CONSTRUCTION PLANS for STATE OF NEW MEXICO METROPOLITAN COURTHOUSE PUBLIC INFRASTRUCTURE MODIFICATIONS ALBUQUERQUE, NEW MEXICO DECEMBER, 2002

RECORD DRAWING

CERTIFICATE OF SUBSTANTIAL COMPLIANCE

TITLE: STATE OF NEW MEXICO METROPOLITAN COURTHOUSE
SITE PLAN

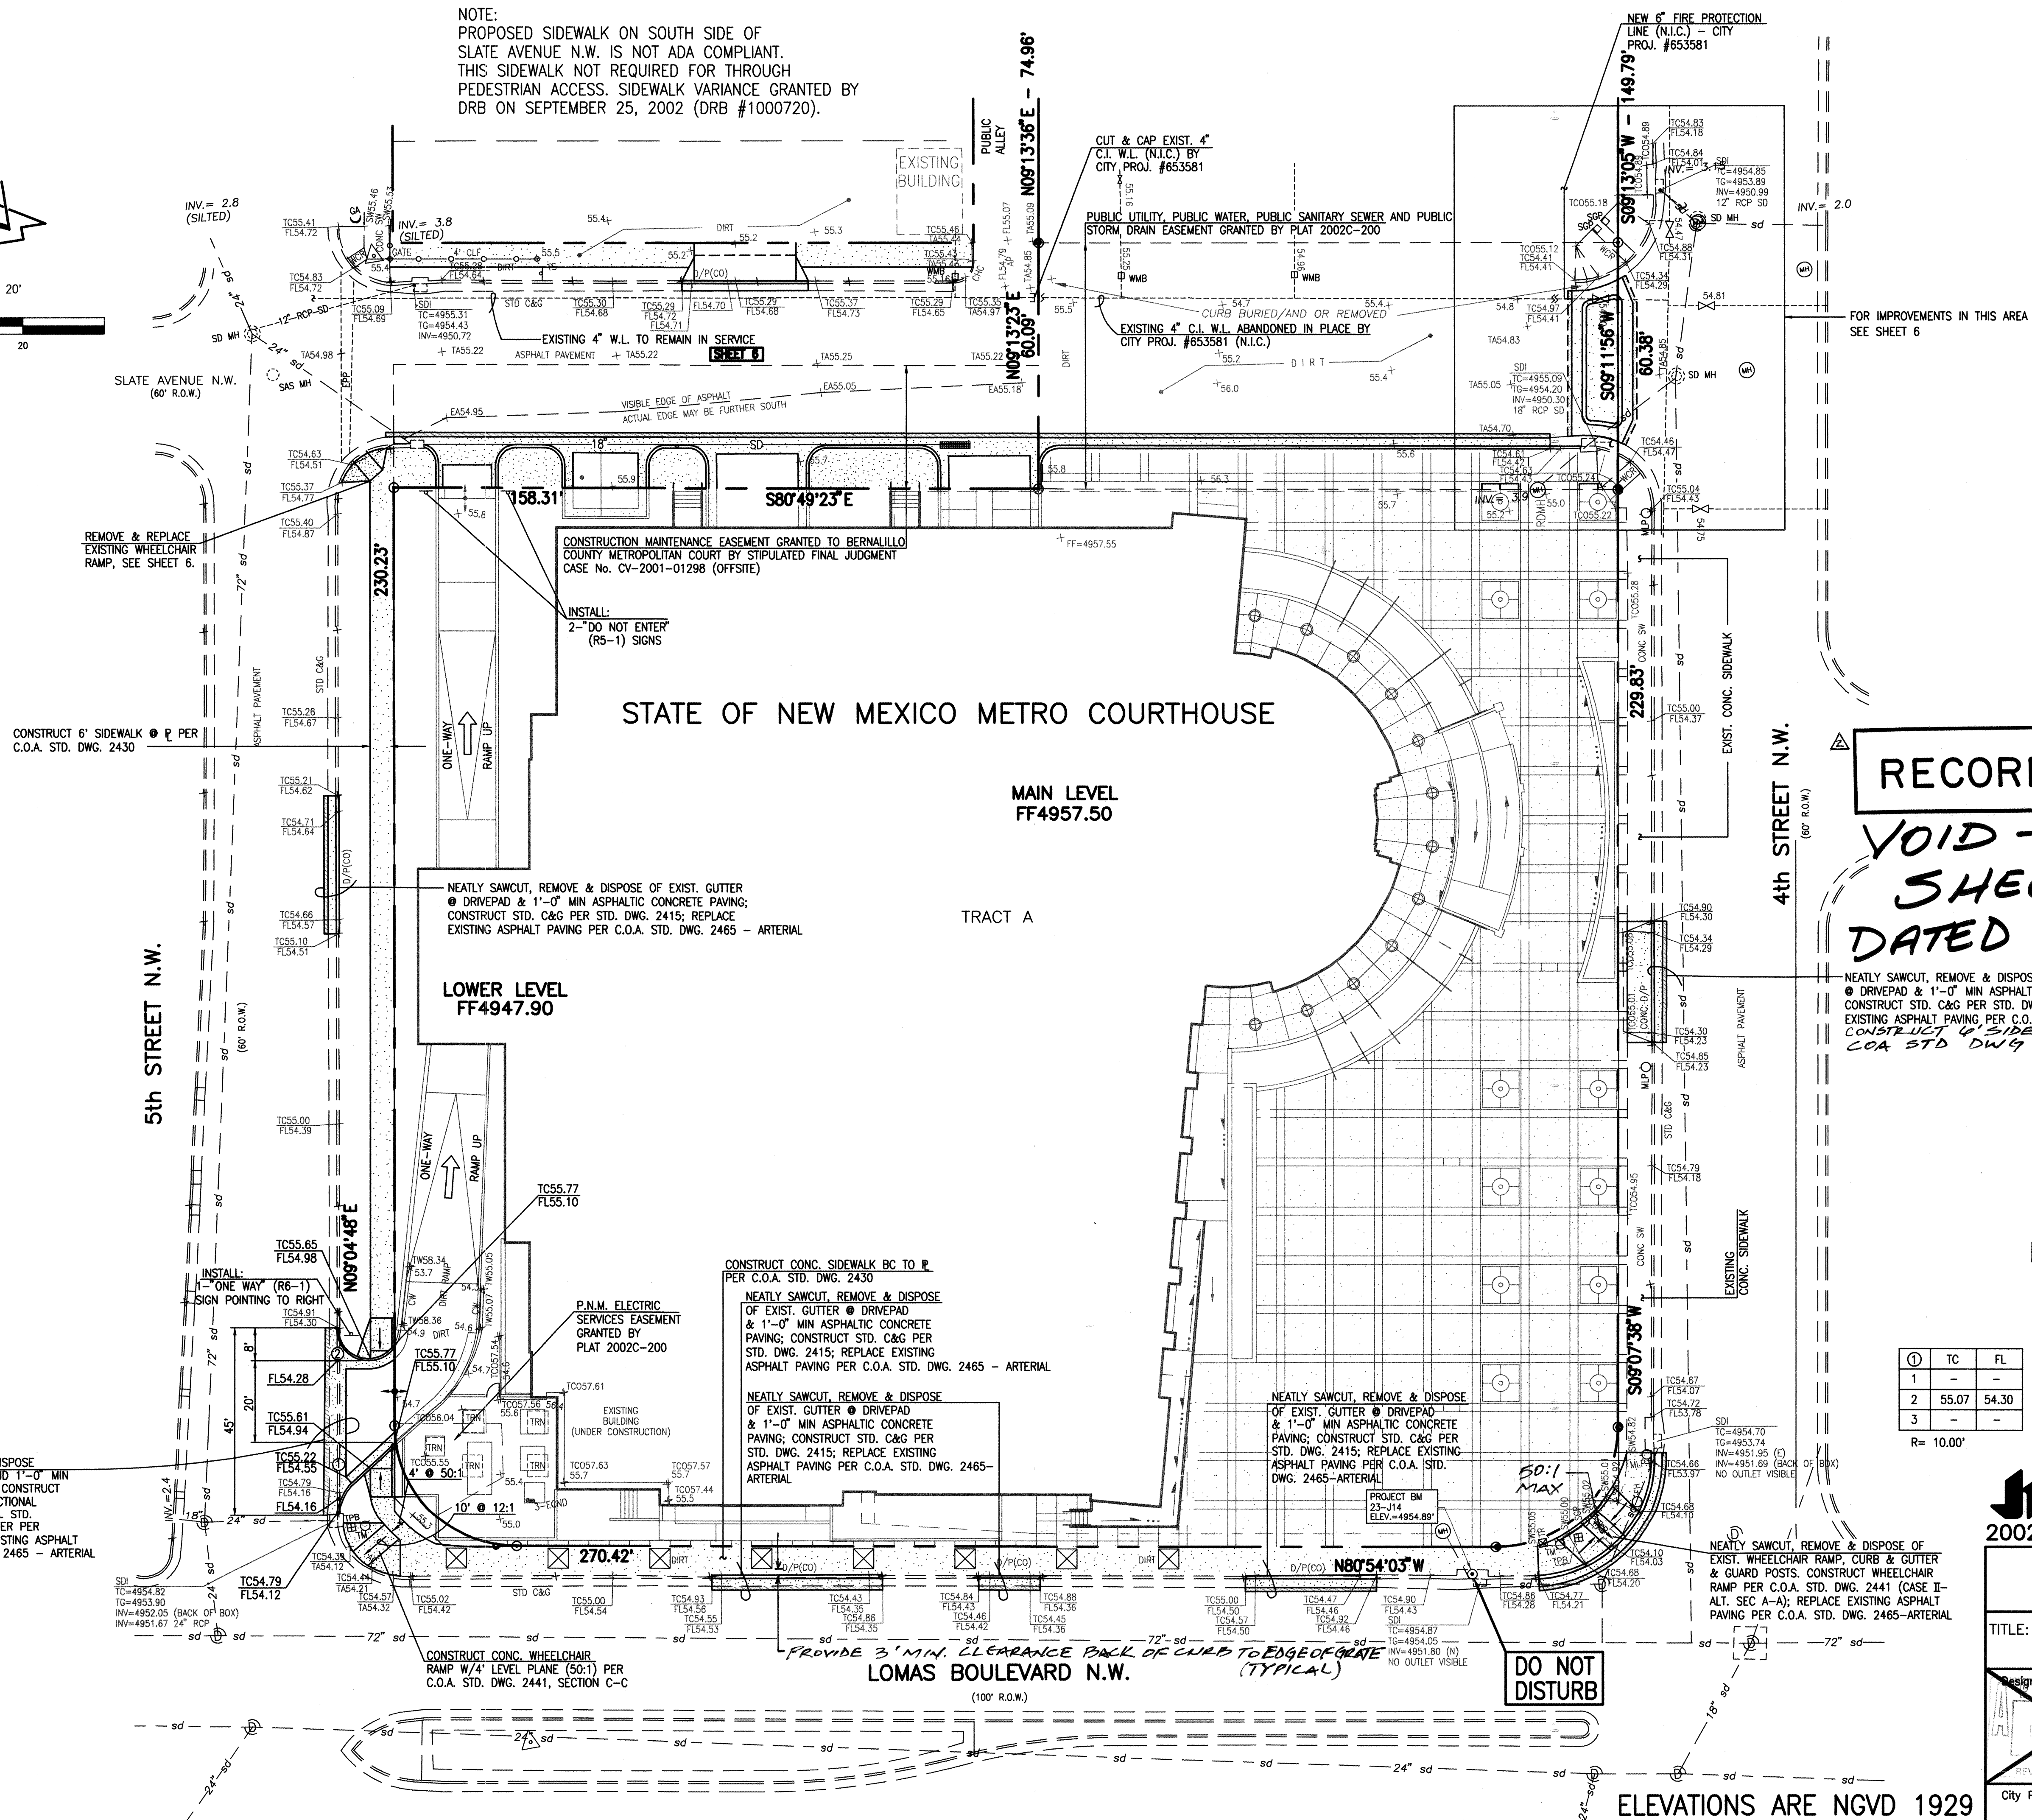
VOID - SEE NEW
SHEET 3
DATED 04-04-2003

TITLE: STATE OF NEW MEXICO METROPOLITAN COURTHOUSE
SITE PLAN

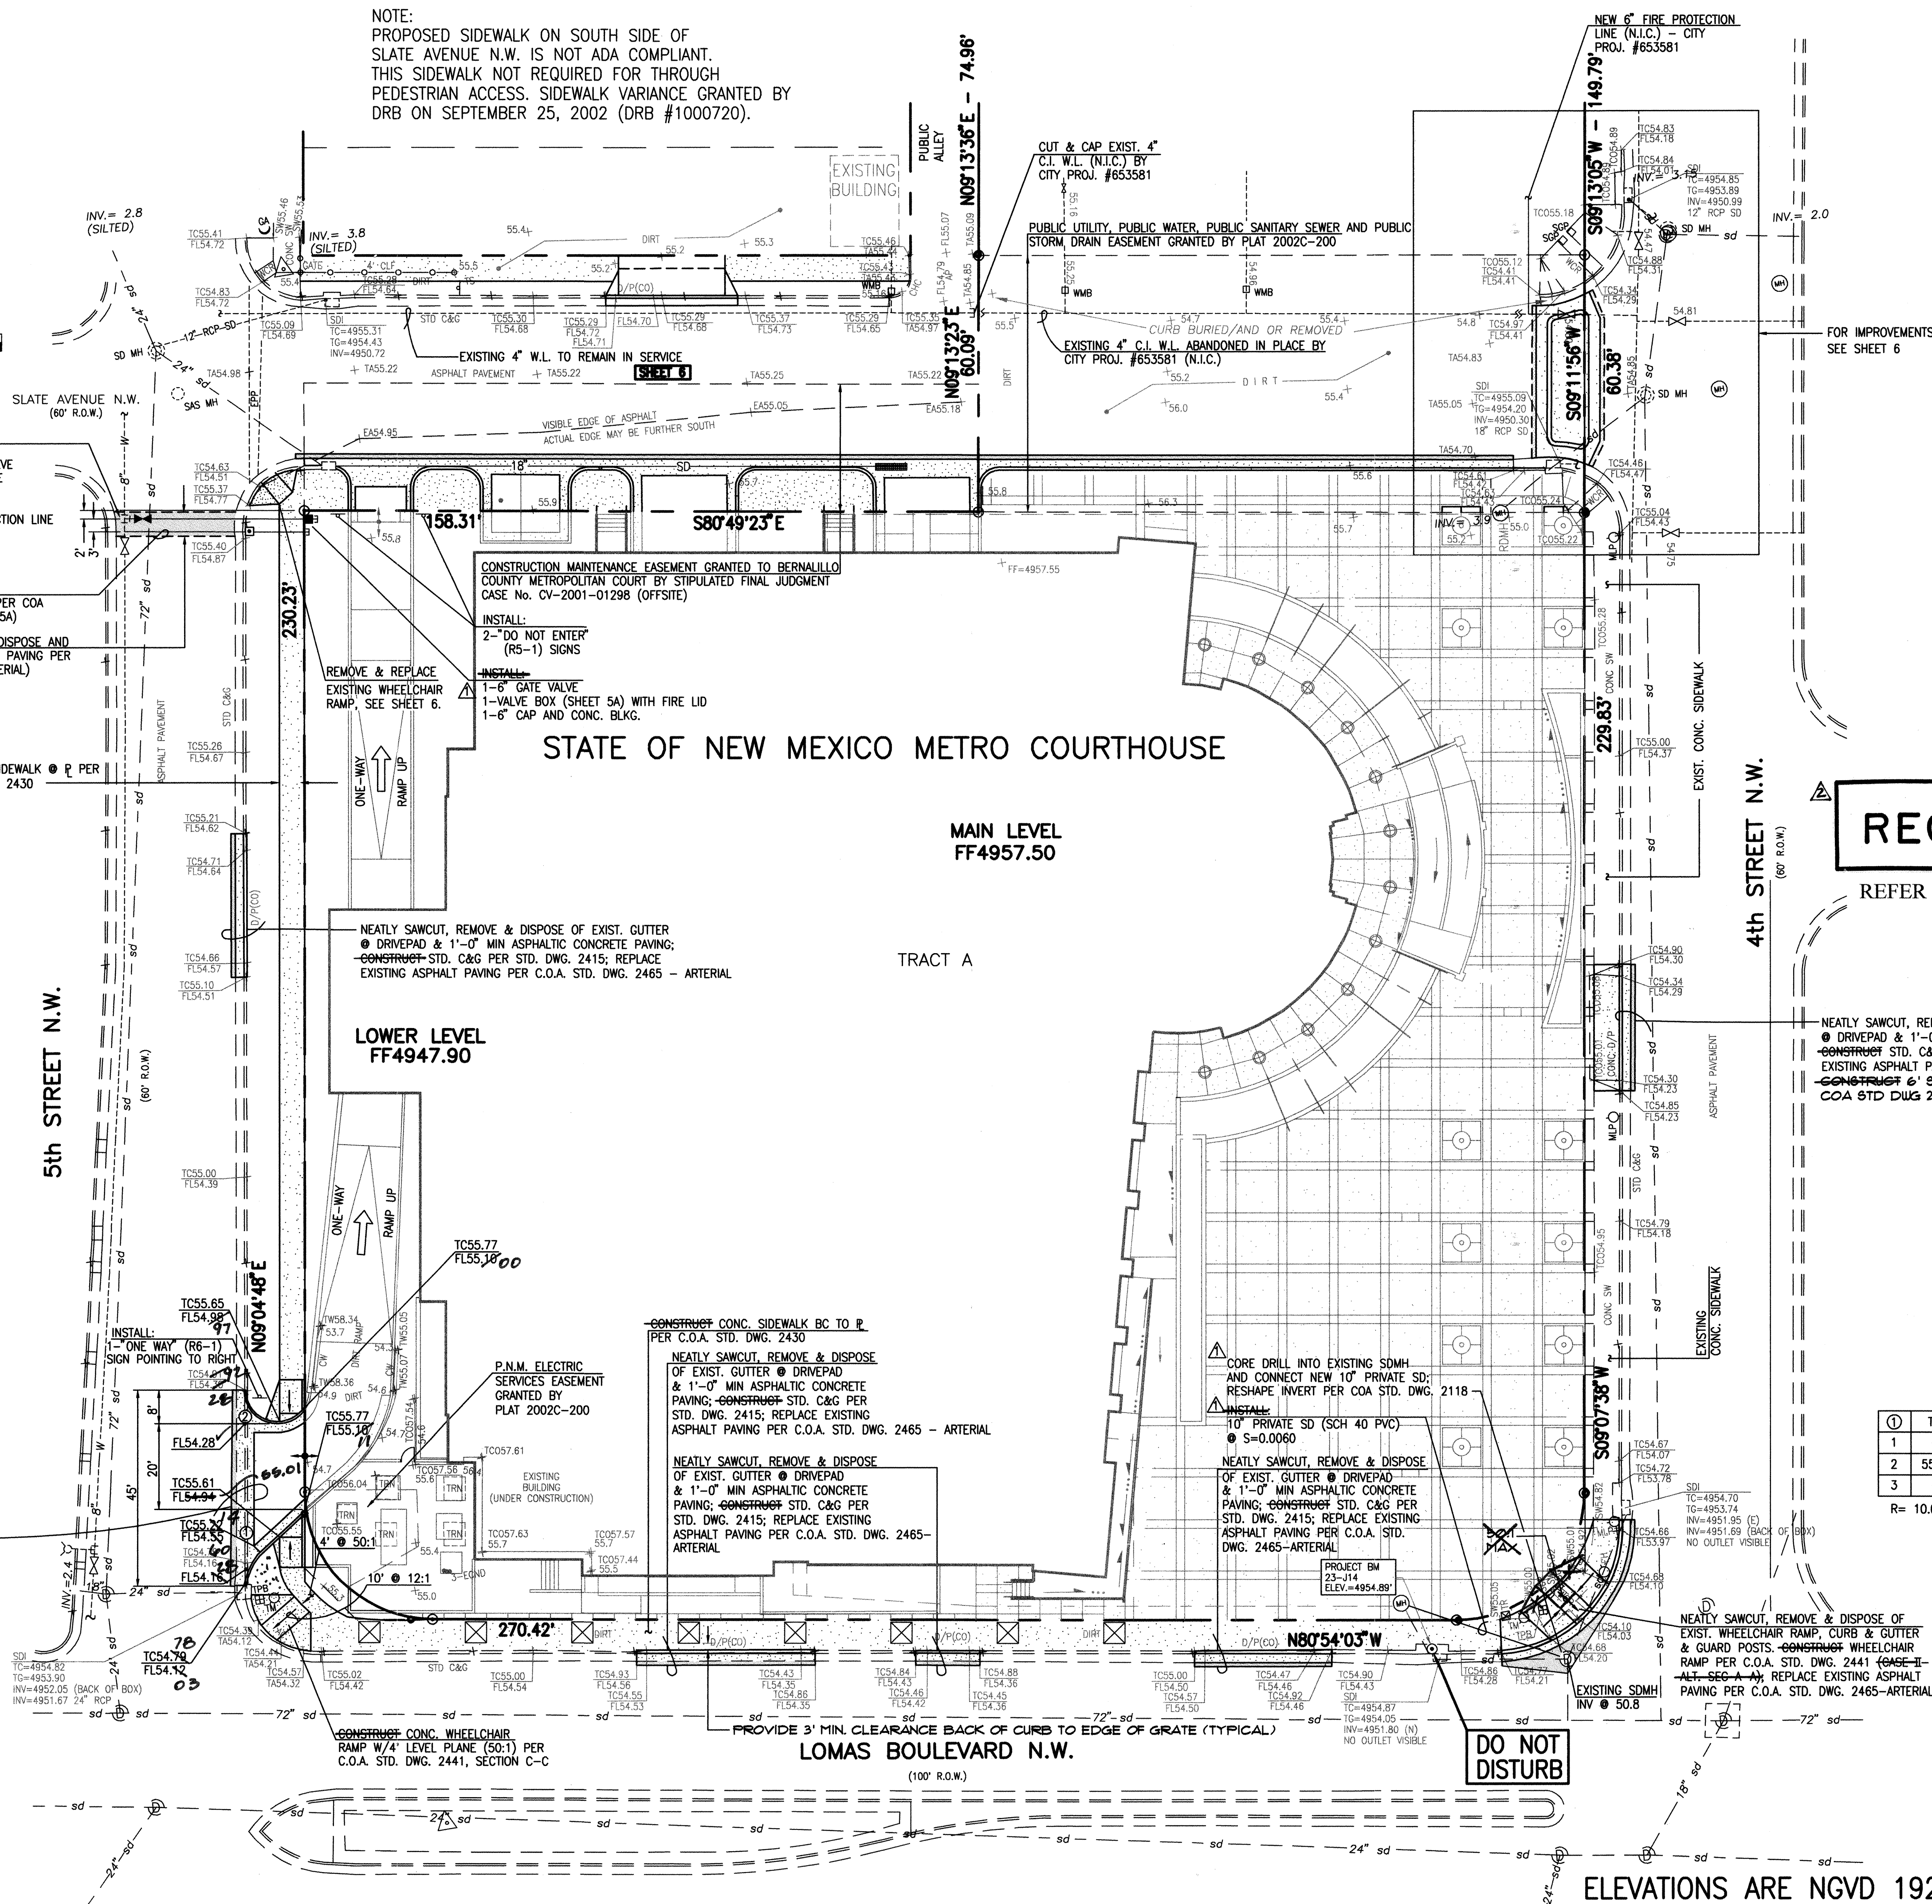
NEATLY SAWCUT, REMOVE & DISPOSE
OF EXIST. CURB & GUTTER AND 1'-0" MIN
ASPHALTIC CONCRETE PAVING; ~~CONSTRUCT~~
PRIVATE ENTRANCE W/UNIDIRECTIONAL
WHEELCHAIR RAMPS PER C.O.A. STD.
DWG. 2426 & 6" VALLEY GUTTER PER
STD. DWG. 2420. REPLACE EXISTING ASPHALT
PAVING PER C.O.A. STD. DWG. 2465 - ARTERIAL

TITLE: STATE OF NEW MEXICO METROPOLITAN COURTHOUSE
SLATE AVENUE N.W. PAVING IMPROVEMENTS PLAN AND PROFILE

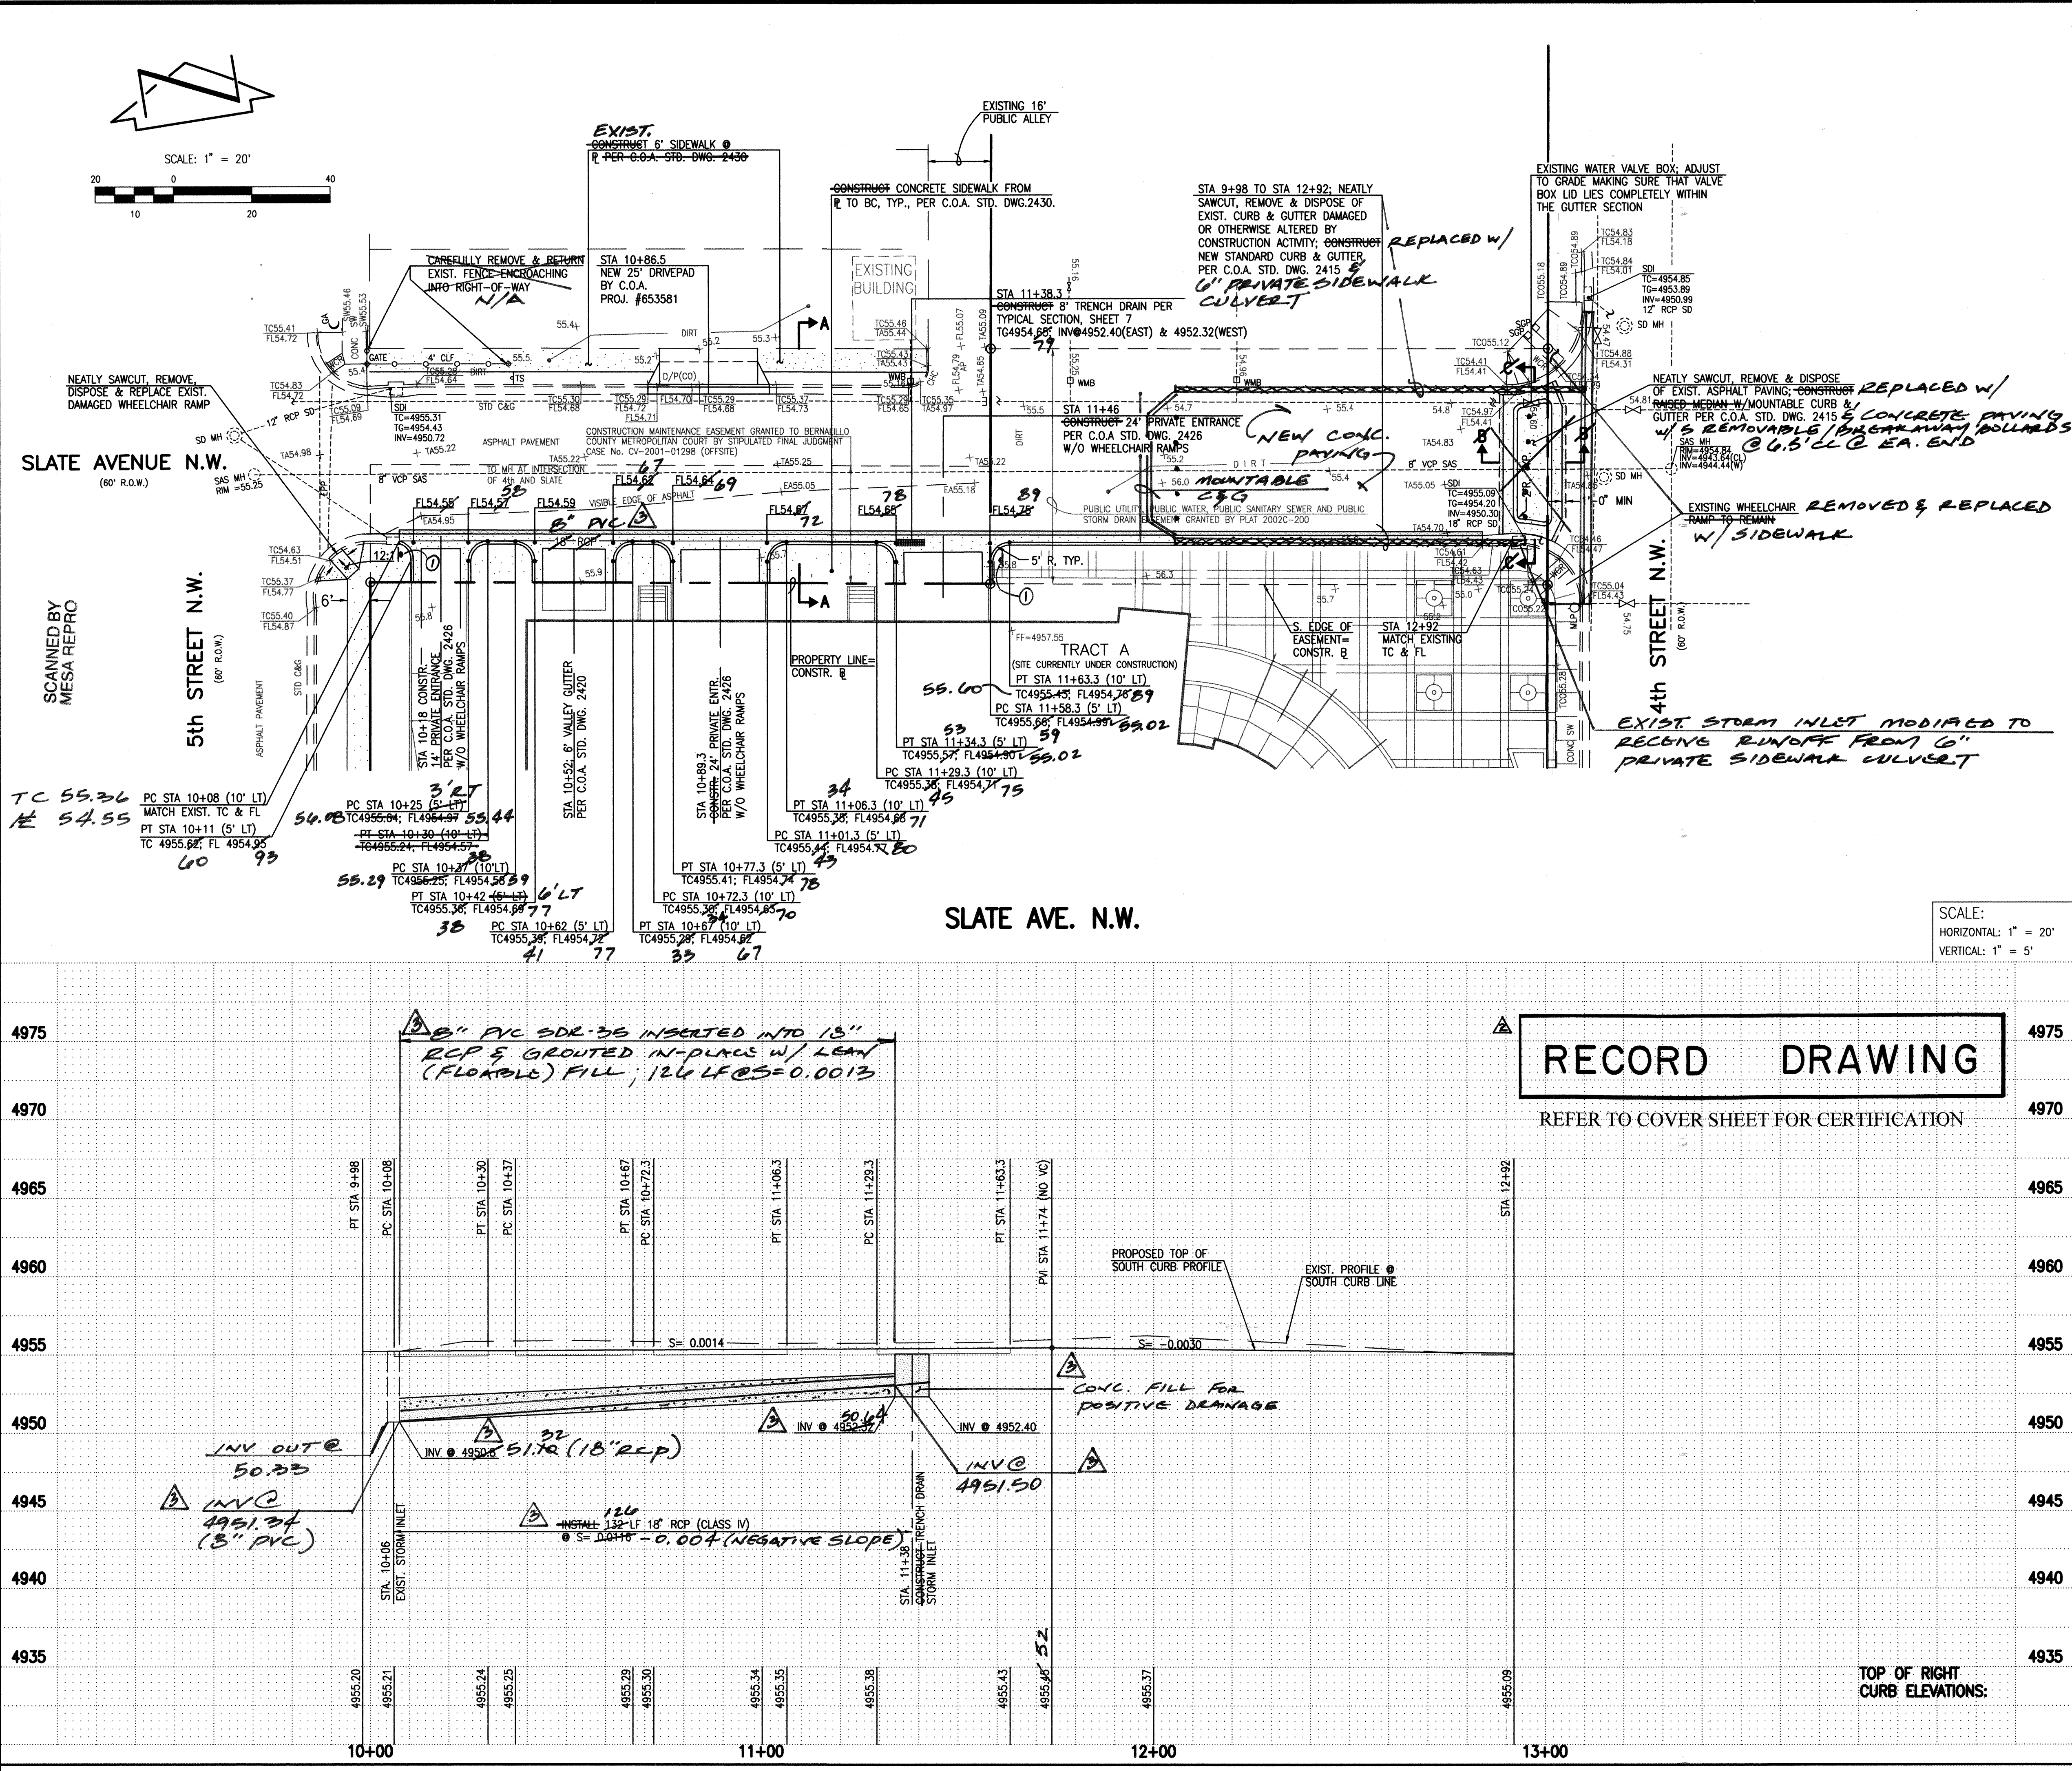
1. THE PUBLIC STORM DRAIN IN SLATE AVENUE NW HAS NOT BEEN INSTALLED TO THE DIMENSIONS AND CAPACITY AS DESIGNED OR INTENDED AND MORE IMPORTANTLY AS APPROVED.
2. THE CLOSURE OF VACATED SLATE AVENUE NW AT FOURTH STREET NW DEVIATES FROM THE APPROVED DESIGN, HOWEVER, SATISFIES THE ORIGINAL DESIGN INTENT.
3. THE EXISTING PUBLIC STORM INLET LOCATED AT THE WSW CURB RETURN OF THE INTERSECTION OF FOURTH STREET NW AND VACATED SLATE AVENUE NW HAS BEEN MODIFIED AND AS SUCH IS NOW A PRIVATE STORM INLET. THIS CHANGE DOES NOT CONFLICT WITH THE INTENT OF THE APPROVED PLANS.
